Subject: Reportable defect with NEI voltage regulator
voltage adjust potentiometer

Report No. 10CFR21-0073
FEBRUARY 27, 1996

**10CFR21 REPORTING OF DEFECTS
AND NON-COMPLIANCE**

COMPONENT: Chicago Telephone Supply (CTS), p/n 115R251A
Voltage Adjust Potentiometer

VOLTAGE ADJUST POTENTIOMETER "R4"
NEI DRAWING A-01068
CHICAGO TELEPHONE COMPANY POTENTIOMETER #115R251A

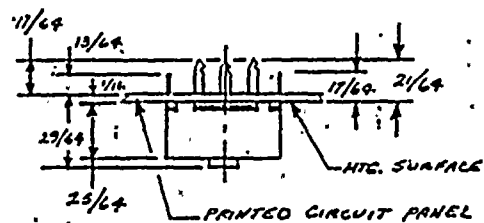
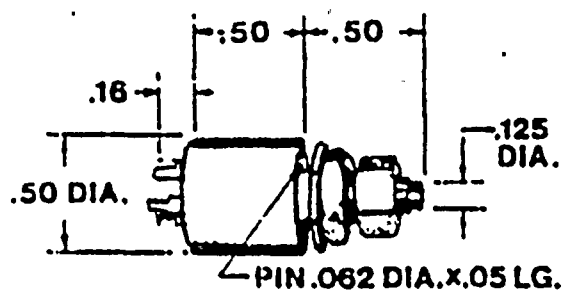
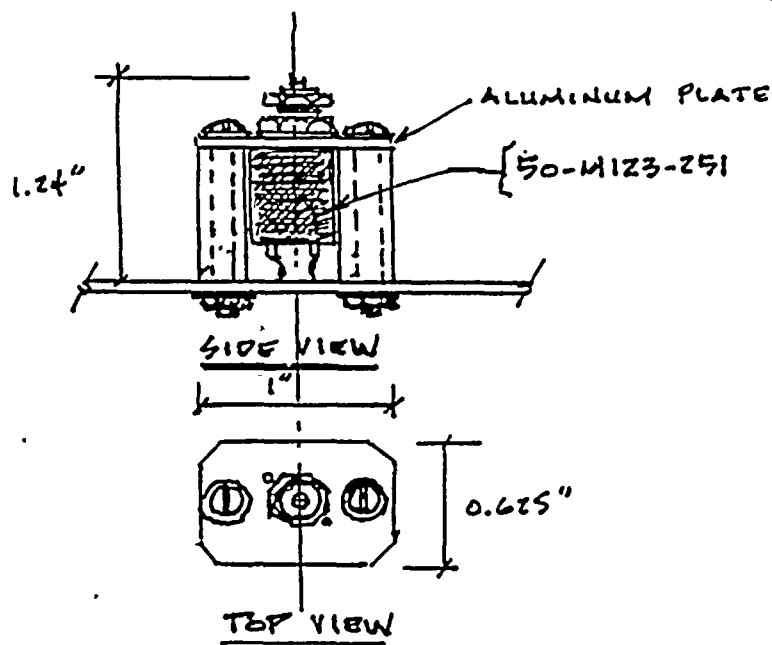
Microscopic examination of the potentiometer showed foreign material on the surface and edge of the stationary slip-ring under the wiper arm collar. The material on the edge was translucent/white-ish and appeared to be a lubricant. The material on the surface was blackish with some white flakes. It is postulated that the lubricate accumulated contaminants and/or dried on the surface. The total amount of foreign material is very small.

- 1) FP&L is in the process of updating their voltage regulators with the Maury potentiometer. Other users should be aware of this possible problem and monitor their EDG output voltage for unstable output during routine testing. Replacement of the potentiometer is dependent upon monitoring/testing. Immediate response to this notification does not appear to be necessary as the majority of the in-service voltage regulators have been operating without incident for approximately 15-20 years.

"R4" REPLACEMENT
MAURY #50-M-123-251

REPLACEMENT FOR 115R251A USED IN VOLTAGE
REGULATOR 72-13000-100 AS RESISTOR R4.
